Project Title: Refurbish Elevators and Replace Controls

Solicitation Questions and Answers
for
Refurbish Elevators and Replace Controls
Project: 437-22-101, RFP: 36C26324R0021
12/15/2024

Solicitation Questions and Answers (updated 3-26-2024) for
 Refurbish Elevators and Replace Controls
 Project: 437-22-101, RFP: 36C26324R0021

EXISTING 2 HOUR FIRE RATED PARTITION

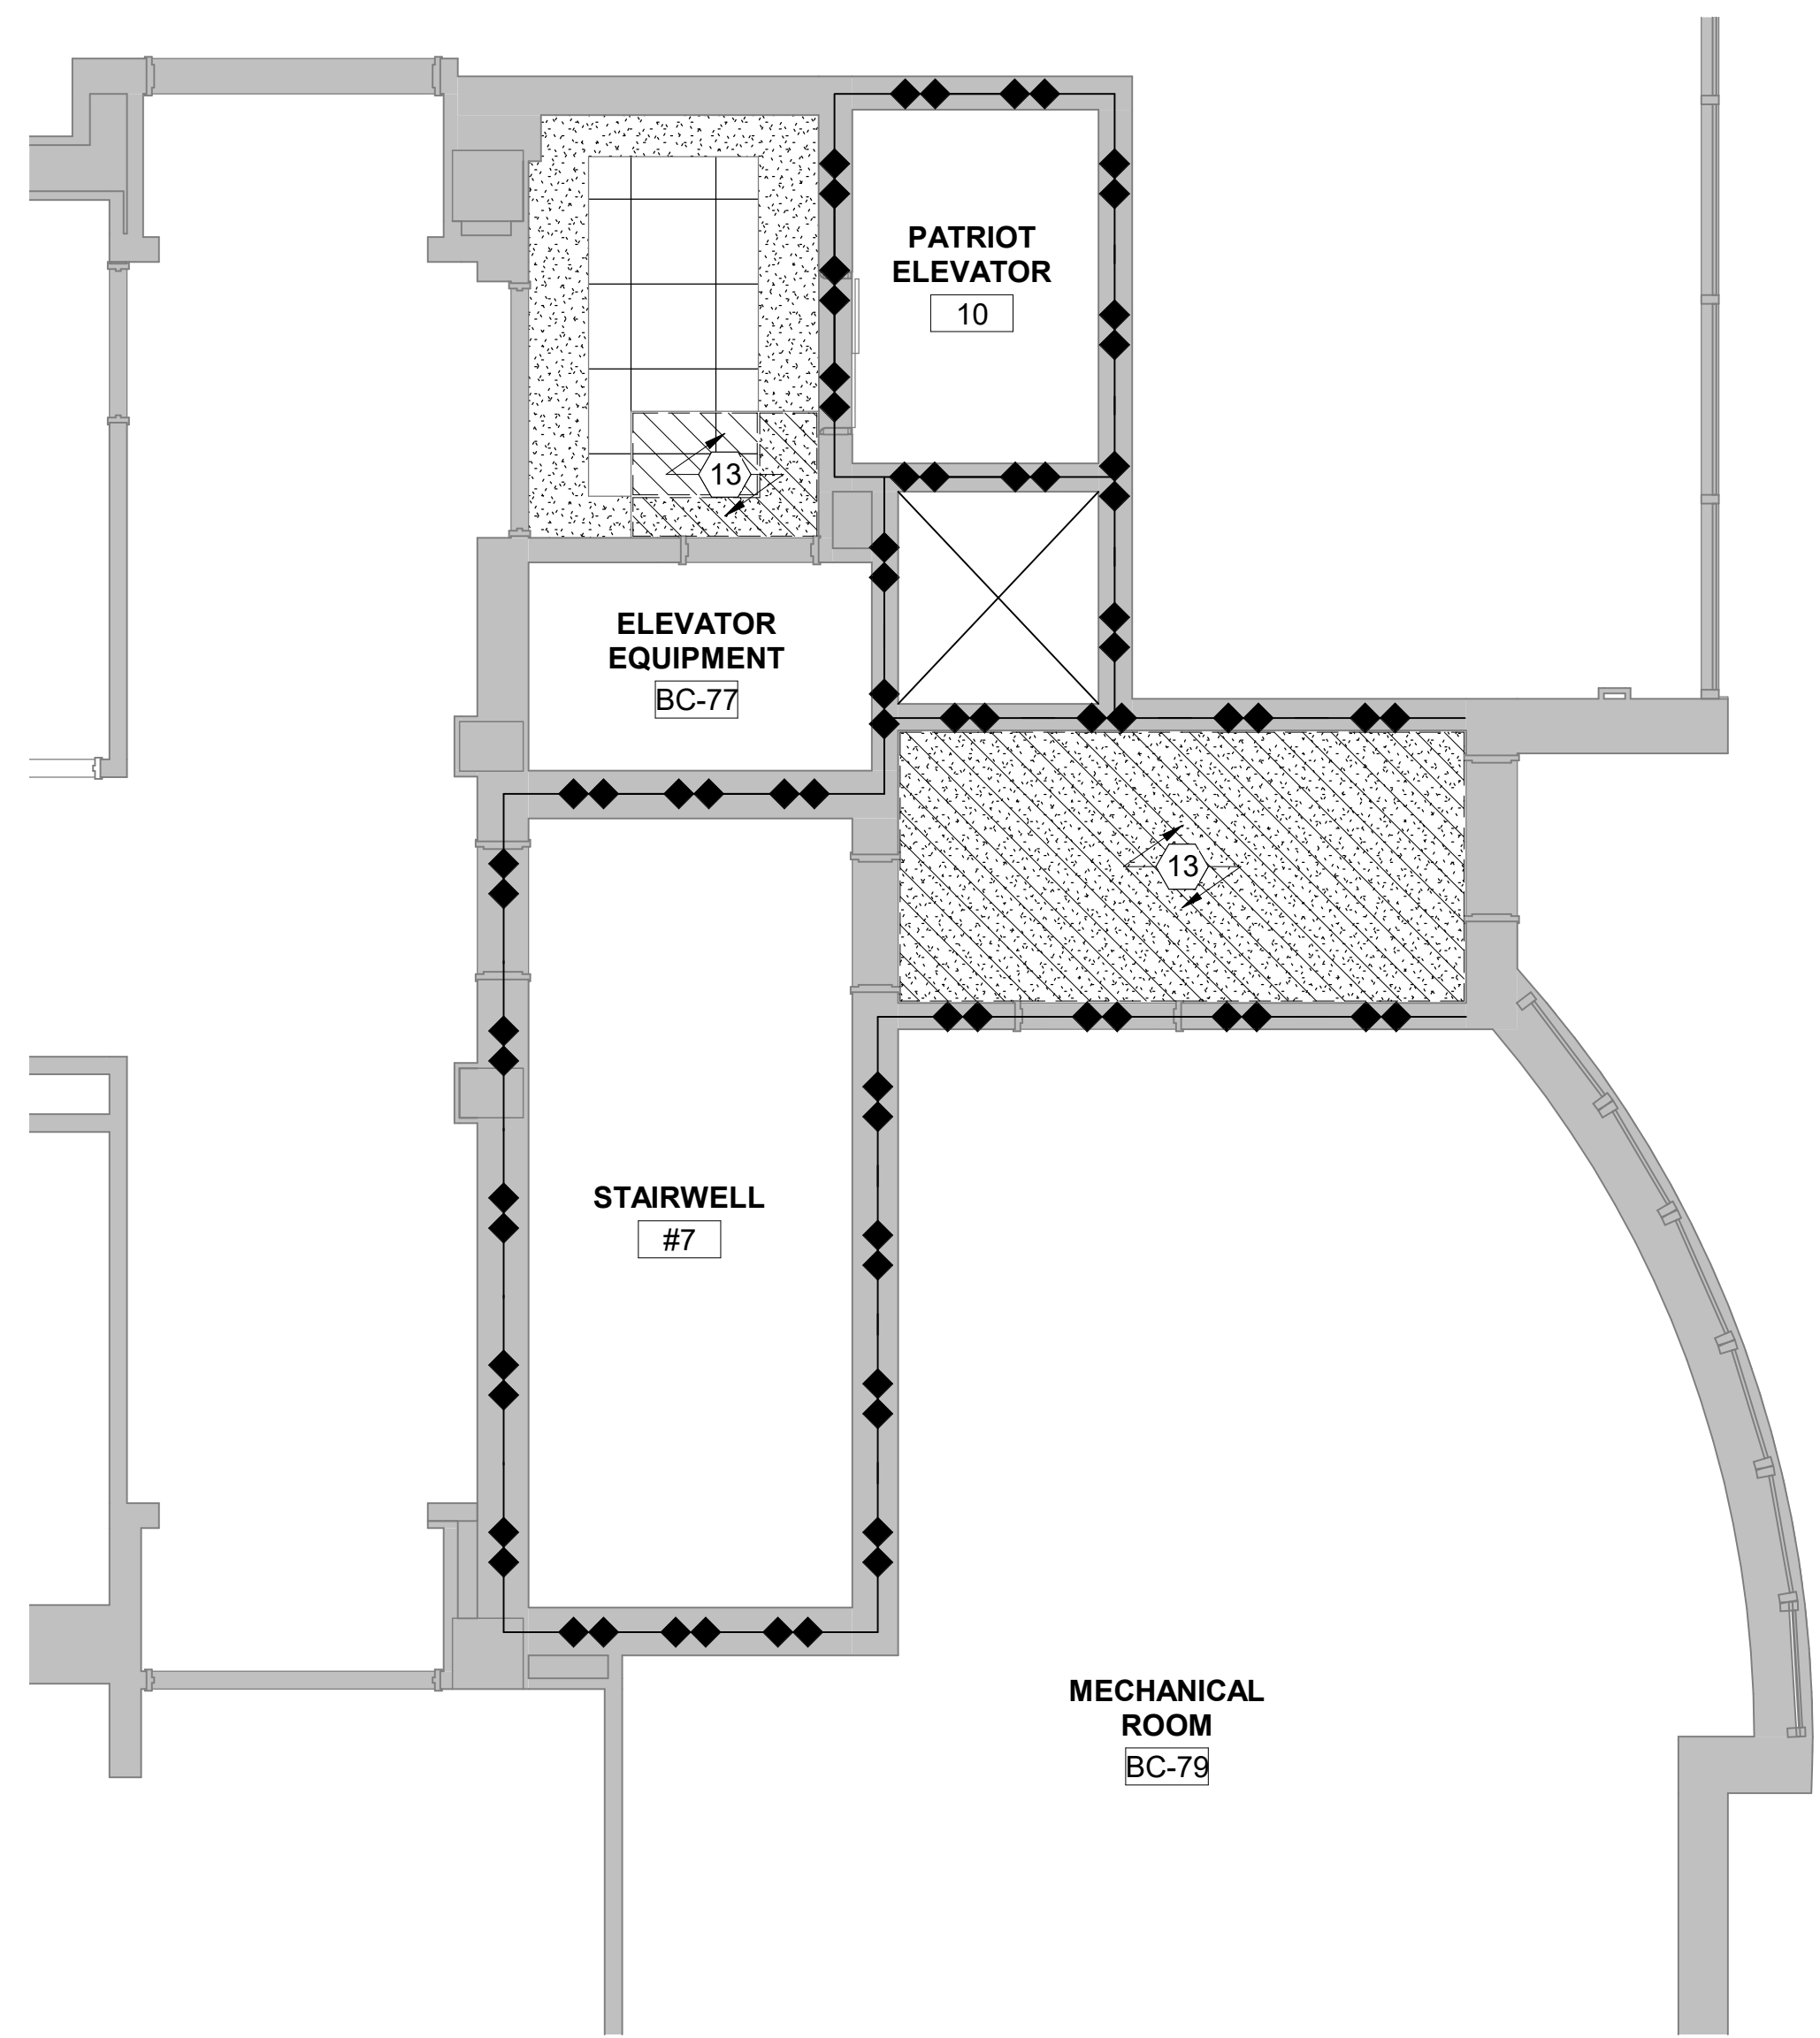
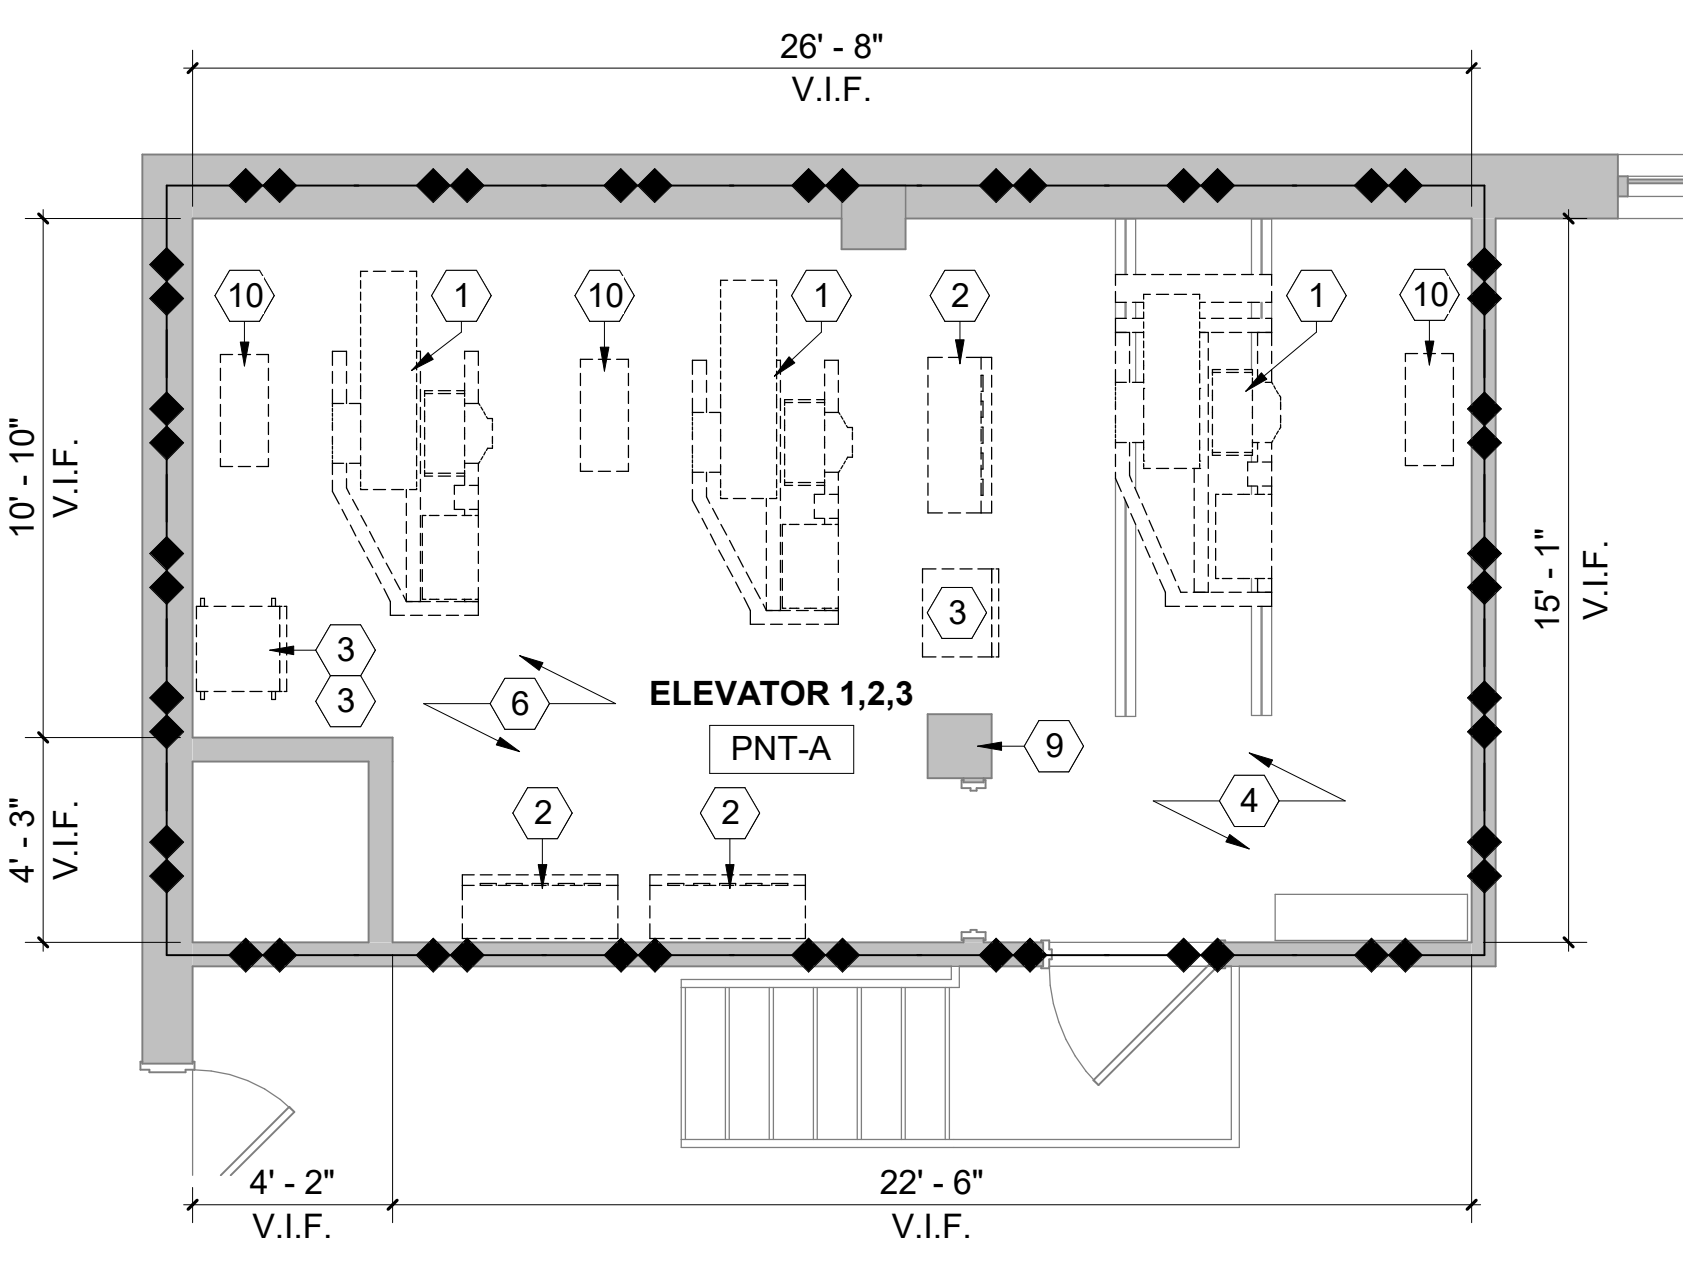
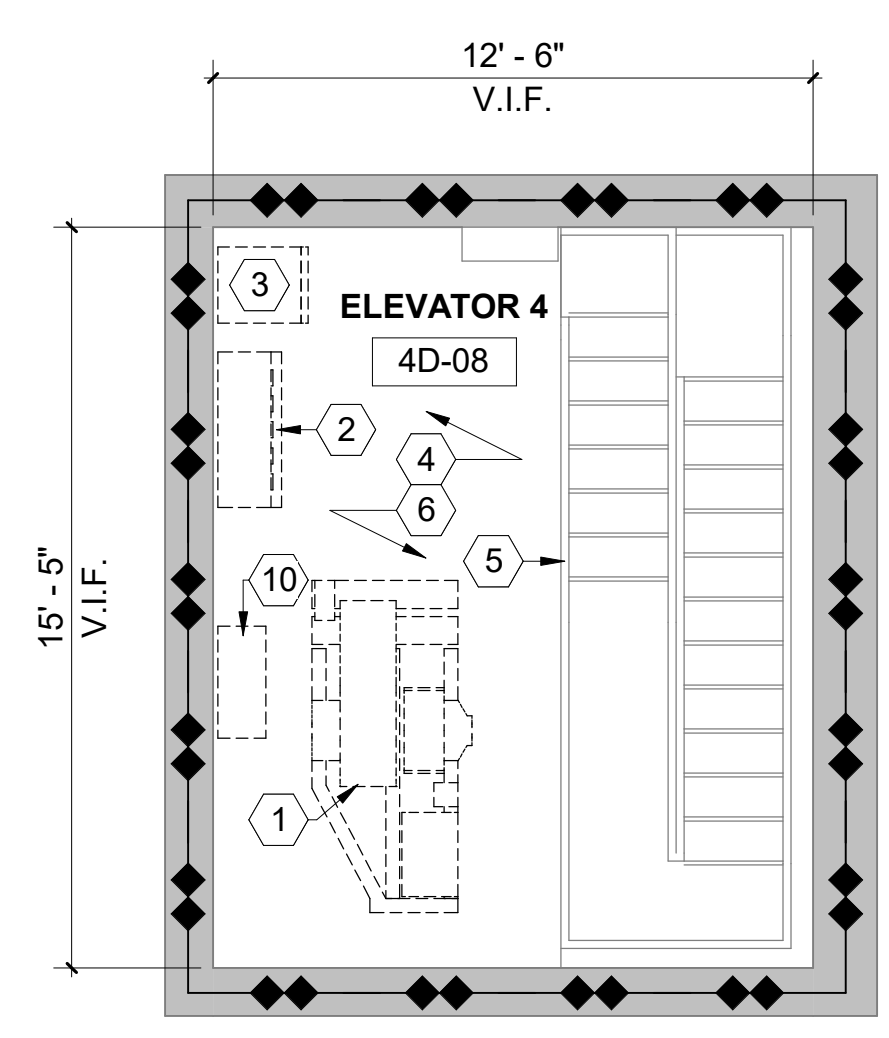
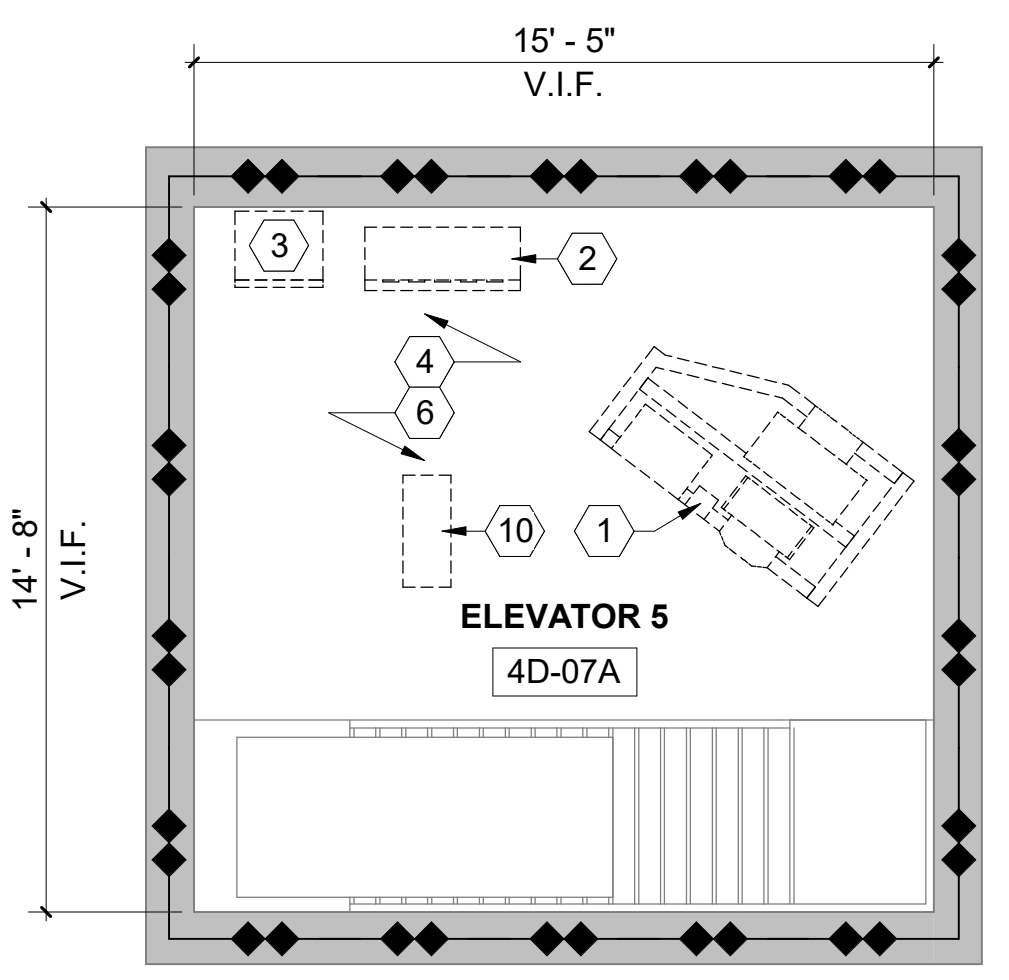
57.	Drawing AD5.22 Key	Key note #1 VS 14 21 10-17 section 2.17	The Specification calls for the geared motor, see update to drawing sheet

note #1	Please confirm if the elevator contractor is to install new gearless elevator hoist machines for elevator 1-8 or geared traction machines as the specifications and drawings conflict and there is a cost difference.	AD5.22 to make all drawing references calling for Geared Motor.

Drawing Sheet AD5.22 ENLARGED PLANS – PENTHOUSE / EQUIPMENT ROOMS - DEMOLITION – See revised drawing sheet for the adjustment of keynotes # 1.
